August 19, 2022

Re: PZC #22-12SITE and #22-14CAM
Garrett Homes, LLC Site Plan Application
1682 & 1686 CT Route 12, Ledyard, CT

STEVE MASALIN, TOWN ENGINEER, AUGUST 8, 2022

National Flood Hazard Layer FIRMette

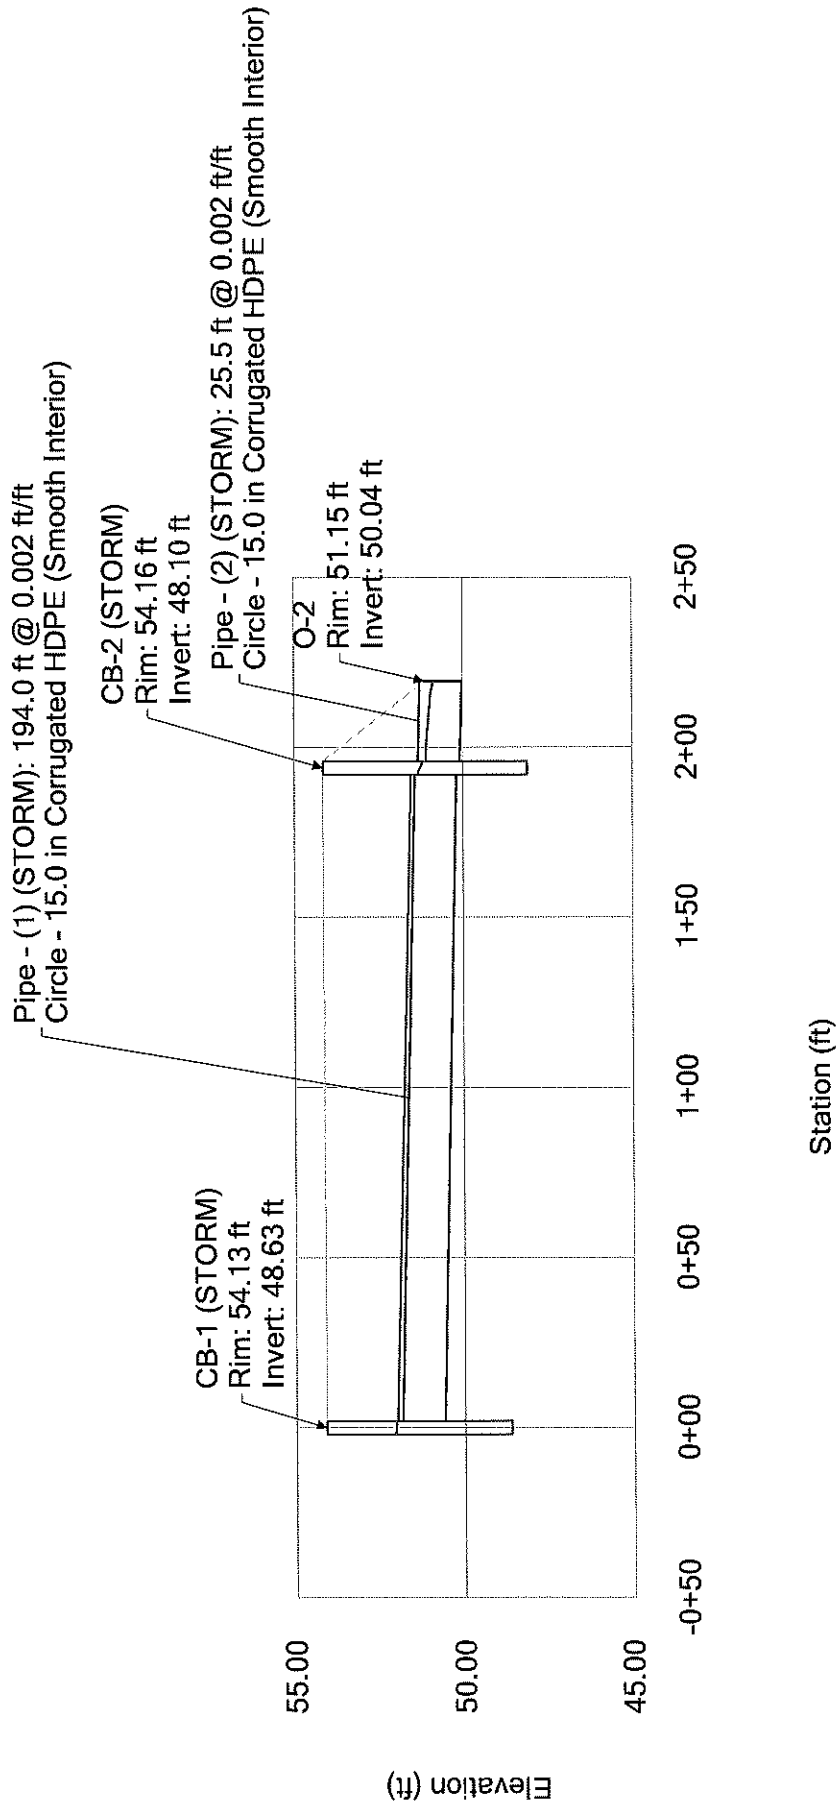
2. Plans and Stormwater Management Report.
a. Appendix A: Figure 3 (FEMA Flood Insurance Rate Map) is illegible.

Response: *A new FEMA Flood Insurance Rate Map is attached to this letter for reference.*

Profile Report
Engineering Profile - CB-1 (STORM) to O-2 (C-CALC-2102412-Proposed Hydraulics-REV 1.stsw)

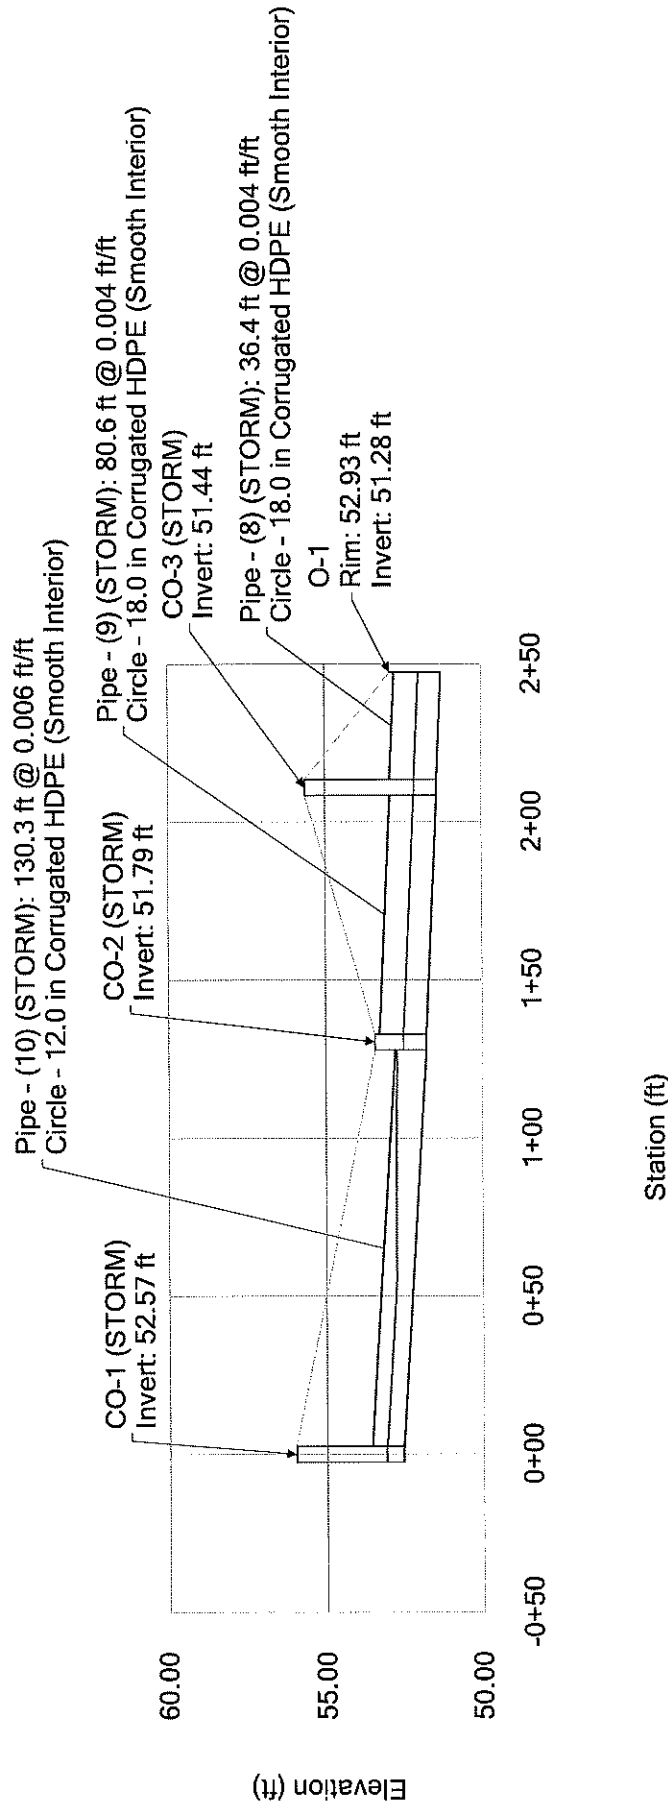
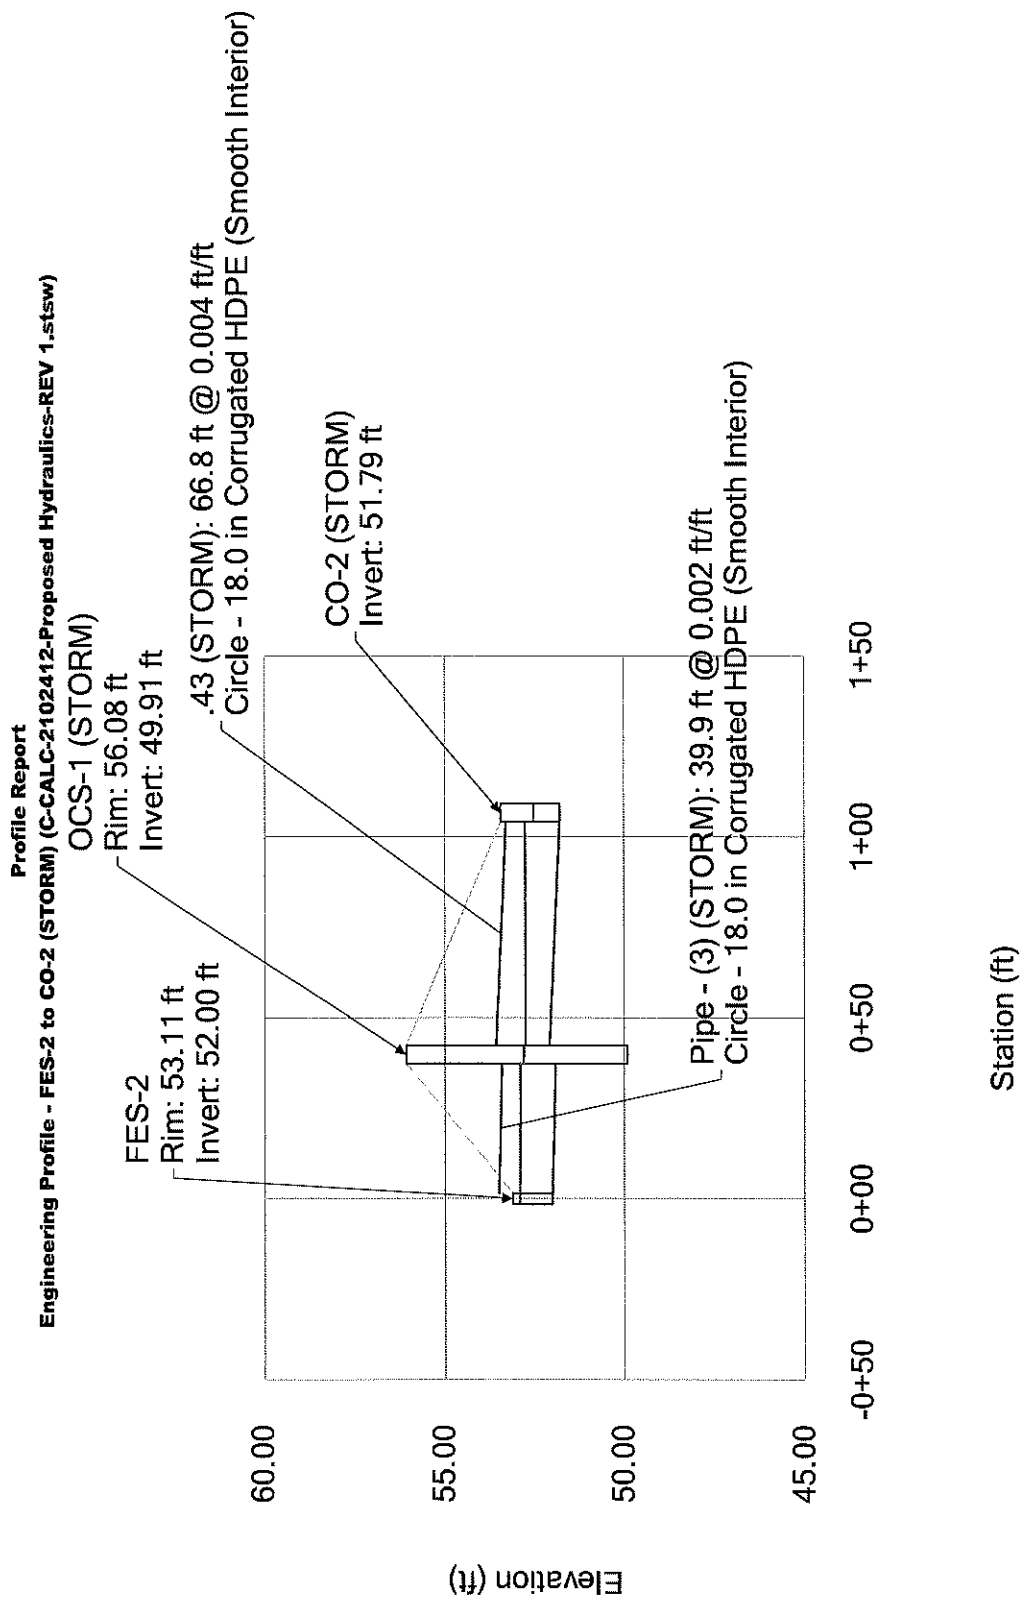
- c. Disparities Between Drainage Plans and Stormwater Management Report Appendix D. There are a number of miscellaneous minor editorial inconsistencies in values (particularly pipe length) that are relatively insignificant, but the following are notable and should be reconciled.

Plans	Report Profiles/Table
12" Downspout Collection Pipe (10)	155 feet	130.3 feet
CO-1 Invert	52.57	52.44
CO-1 TF Elevation	55.97	53.19
CO-3 TF Elevation	55.63	53.08

Response: *The report profiles and table have been revised to match the elevations and pipe lengths on plan sheet GD-1. Revised table and profiles are attached for review.*
